**CHANGE ORDER FORM
(ATTACHMENT A TO SPECIAL CONDITIONS)**

Project: LPC Temporary Faculty Village Project
Date: March 11, 2021
Contractor: Sausal Corporation

Change Order: #01
Contract #: B210281

Project Name: Las Positas Temporary Faculty Village
Project Number: 863-0005
ID: ASI 001
Date: 12/11/2020
Subject: Revision 001 FFE adjustment at Modulars and Removal of Walkway Roof

PROJECT NO. _____
 DATE: 2024.11.11
 SHEET NO. **A0.30S**

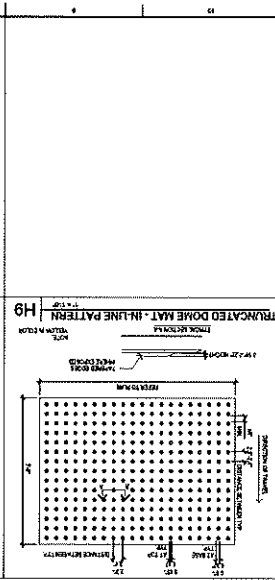
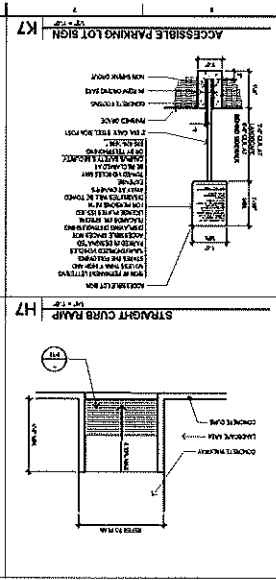
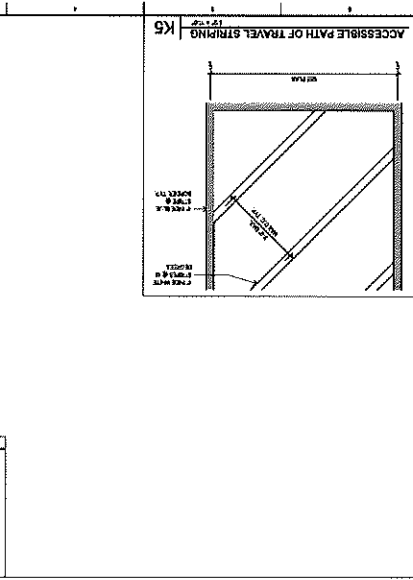
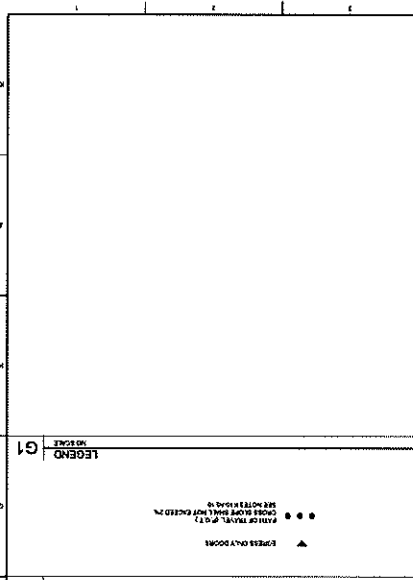
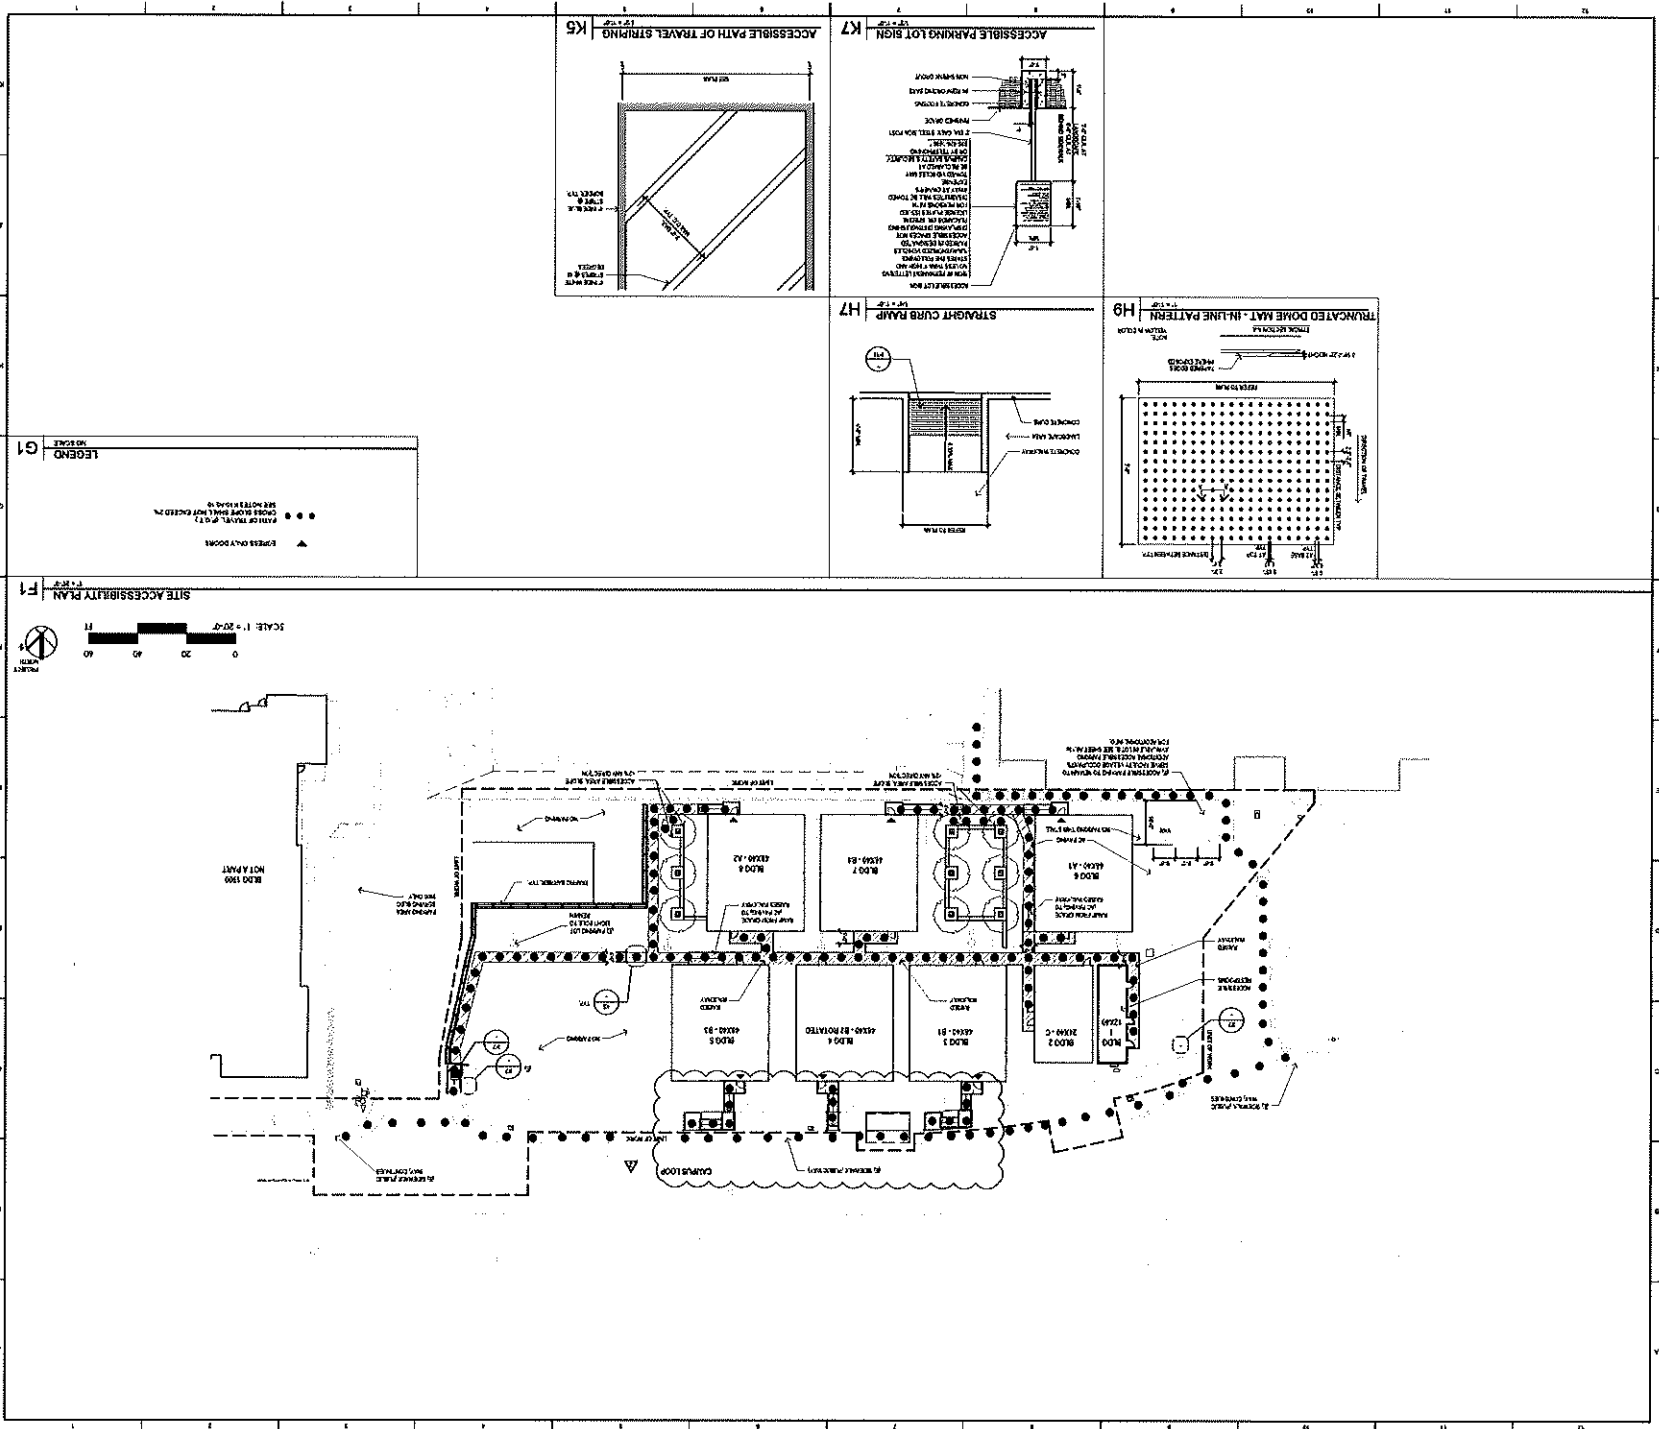
- A0.02s – Revised Sheet Index
- A0.30 – Adjust path of travel symbols per ramp adjustments.
- C2.00 – Revised area of asphalt grind
- C3.00 – Site plan adjustments to match architectural site plan at north ramps at Bldgs 3, 4, 5.

C4.00

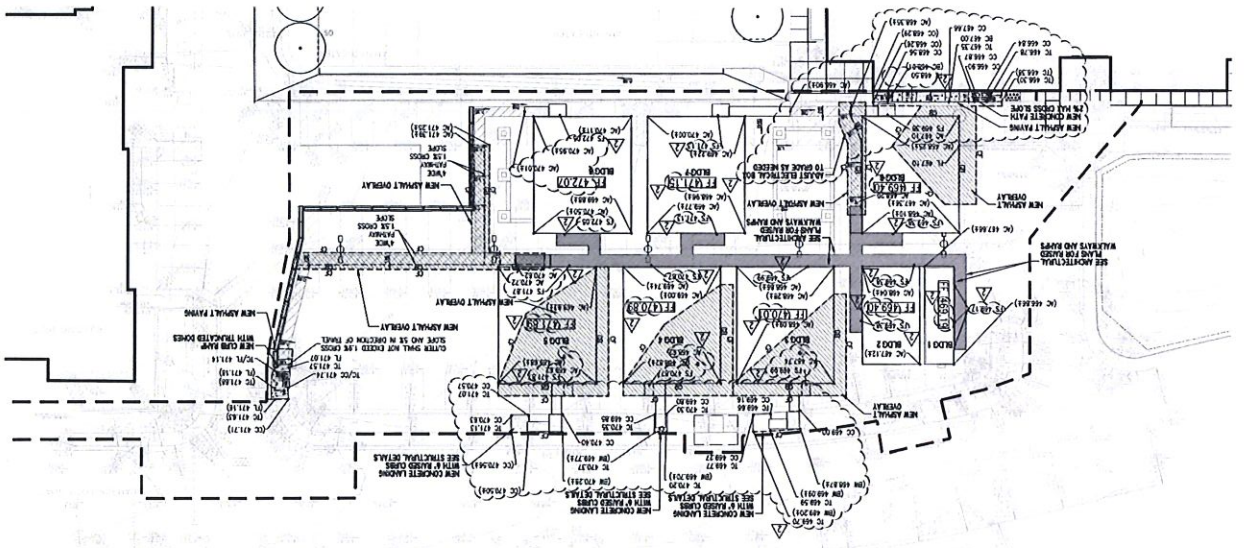
- C4.00 – Adjusted finished floor height of modulars and walkways. Adjust size of landings north of Bldgs 3, 4, and 5.
- C5.00 – Site plan adjustments to match architectural site plan at north ramps at Bldgs 3, 4, 5.

A1.12S
SHEET NO.

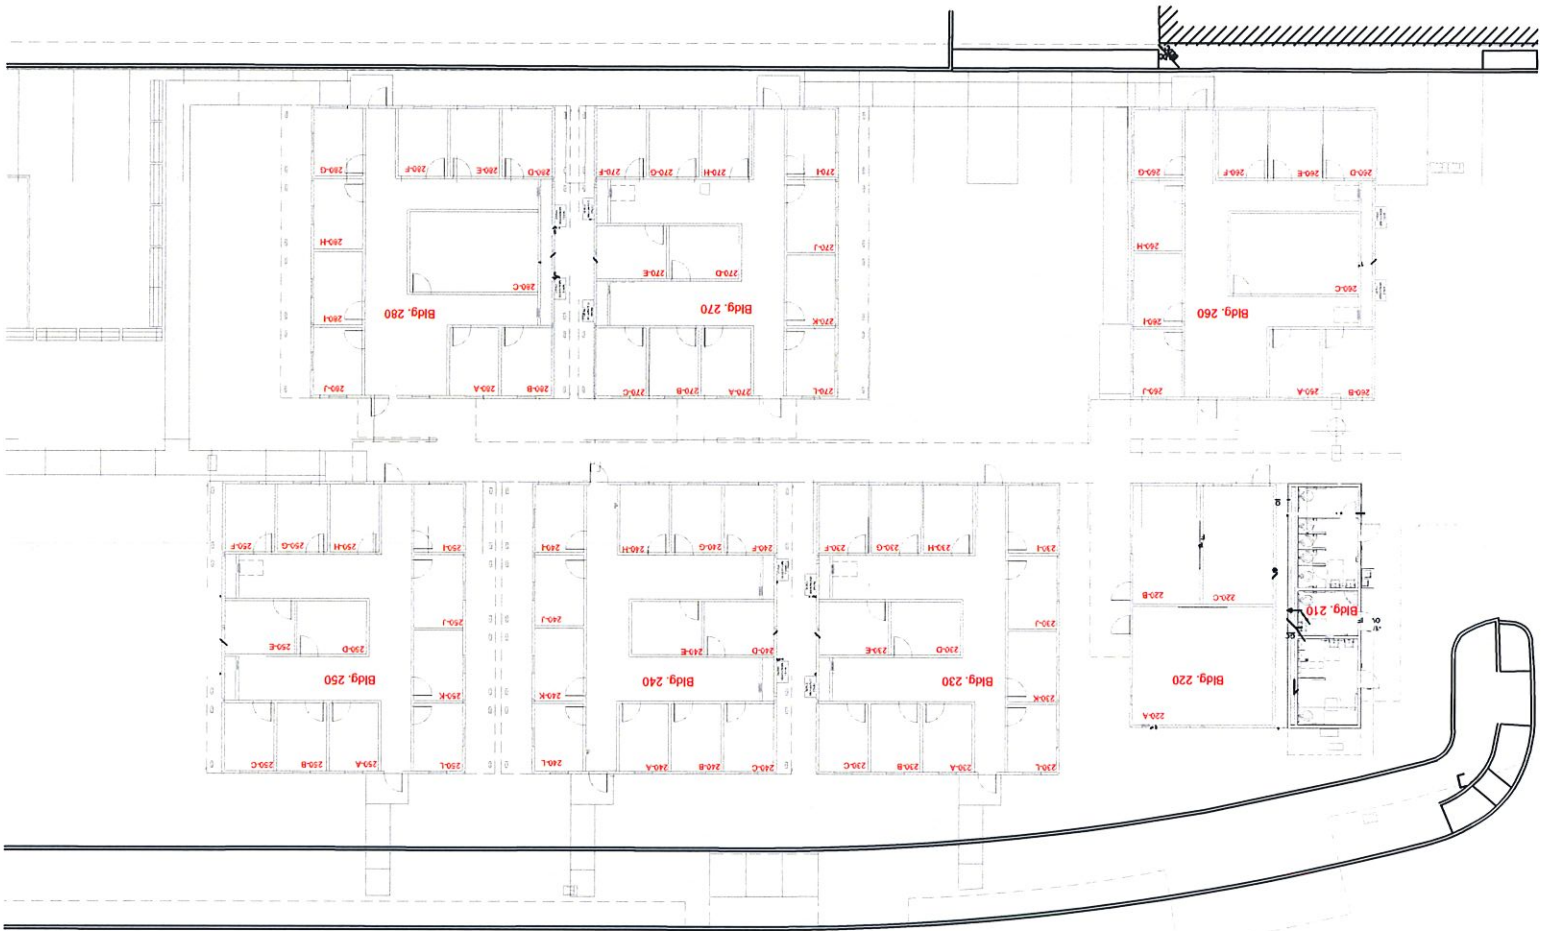
- A1.00s – Ramp lengths adjusted for finished floor height, expand landing on north side of project, added enlarged plans of landings
- A1.12s – New Sheet – room numbers for signage (NOT SUBMITTED FOR DSA REVIEW)

S1.01S

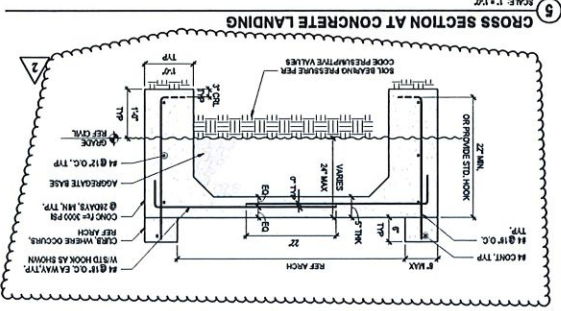
- S1.01s – Remove drilled pier detail, revised concrete landing and housekeeping pads
- S2.01s – Remove roof structure, details and notes
- S3.00s – Remove roof structure details

SHEET NO. S3.01S

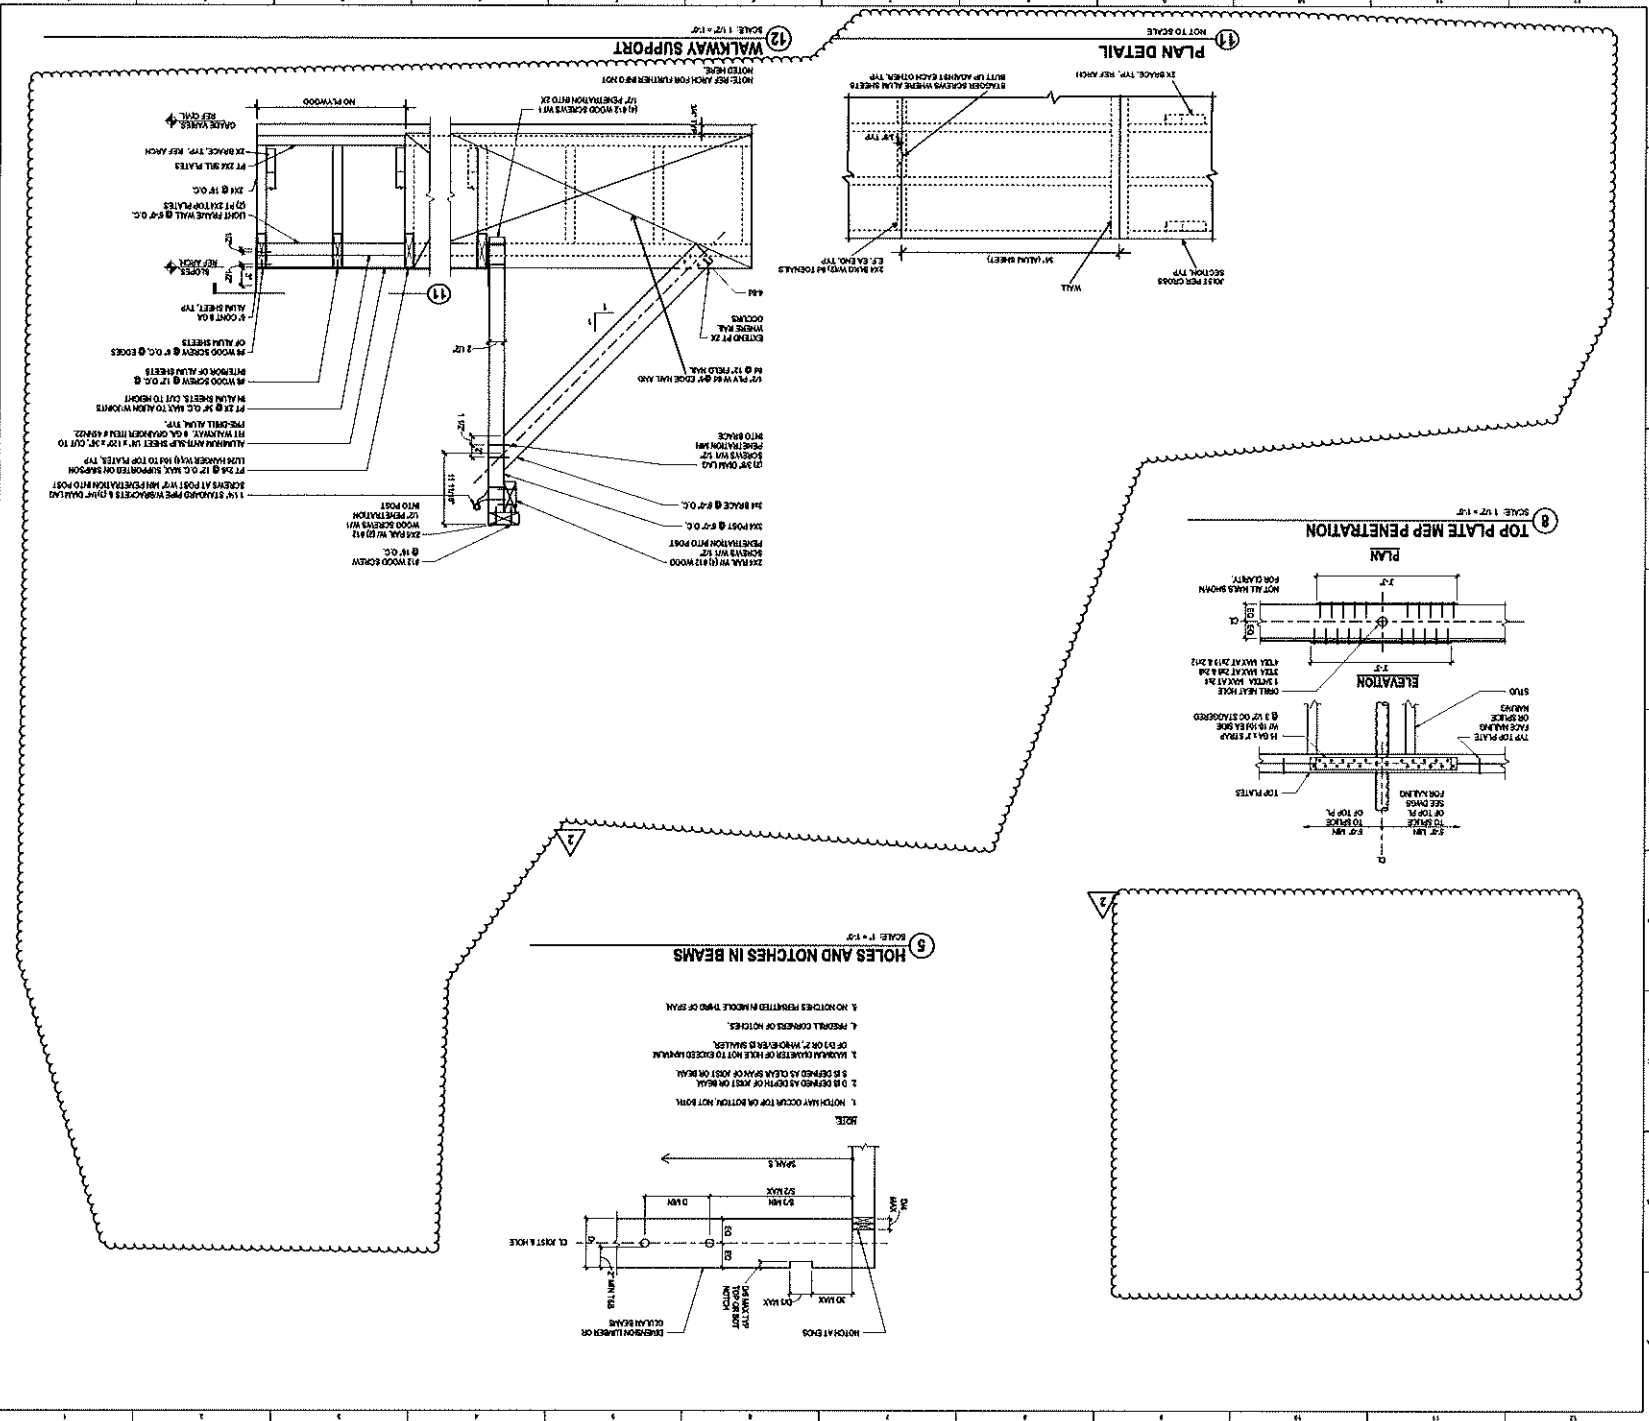
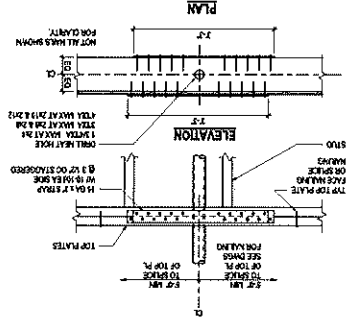
- S3.01s – Remove roof structure details, modified walkway support
- E0.10s – Remove lighting from symbol list, luminaire schedule, updated sheet index to remove sheet E0.30s and E2.10s

E3.10S
SHEET NO.

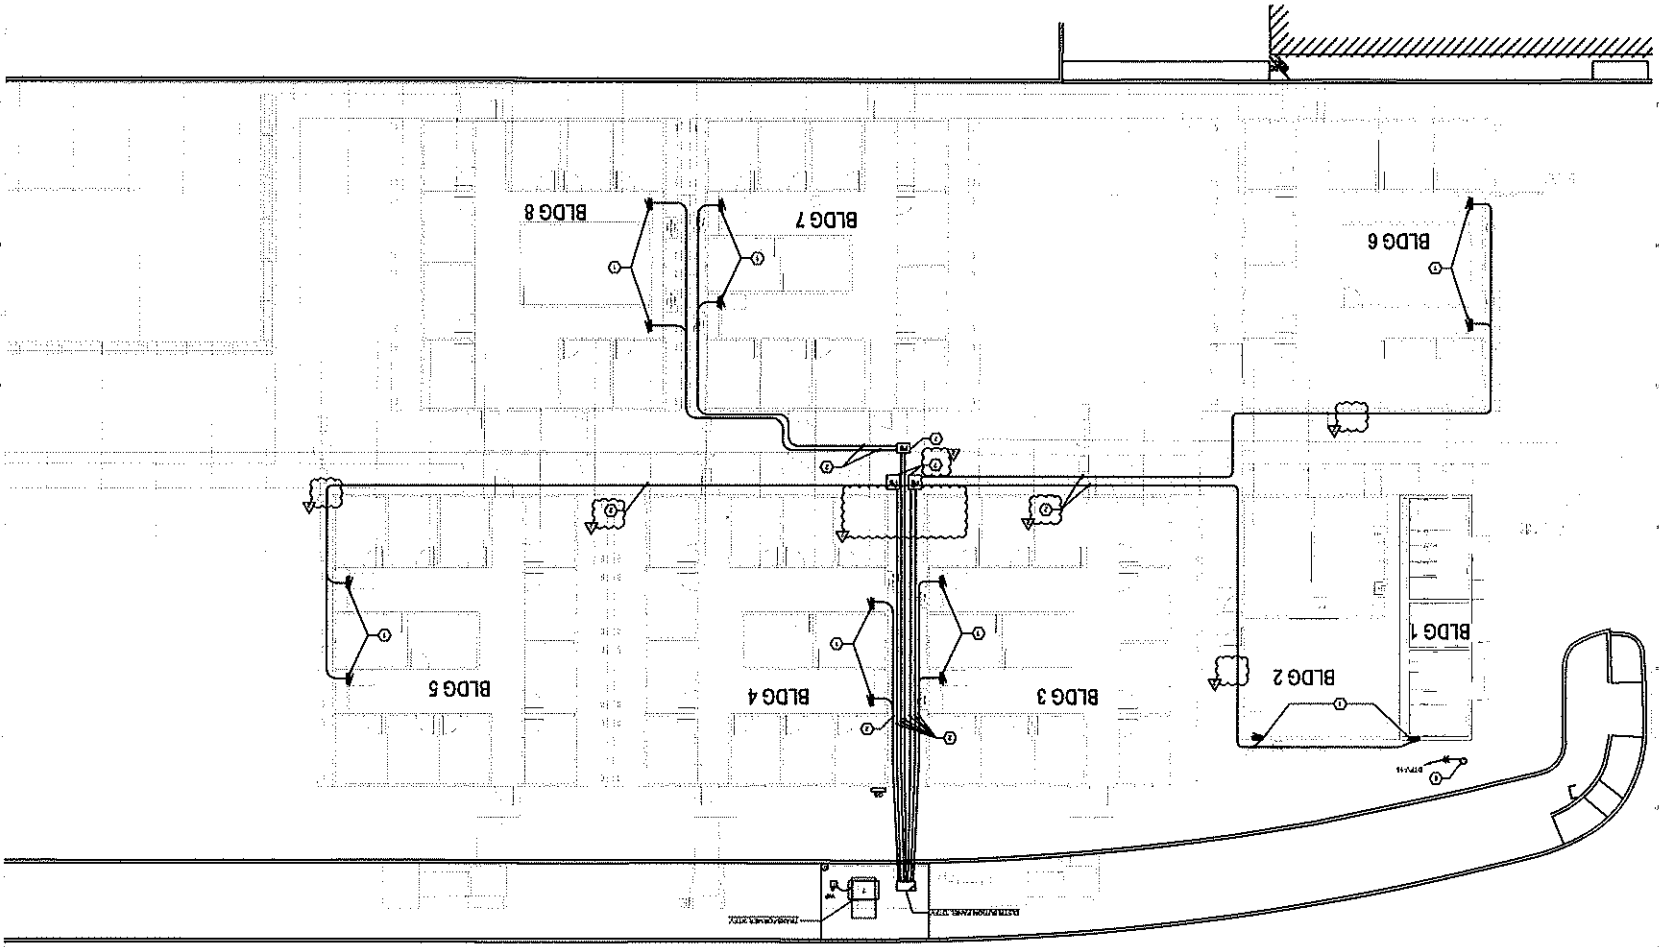
- E3.10s – Remove vertical conduits, edit key notes, edit key note 5 to keynote 2, and keynote 8 to keynote 7
- E4.10s – Remove conduit serving lighting on single line diagram, remove lighting load on panel schedule to spare
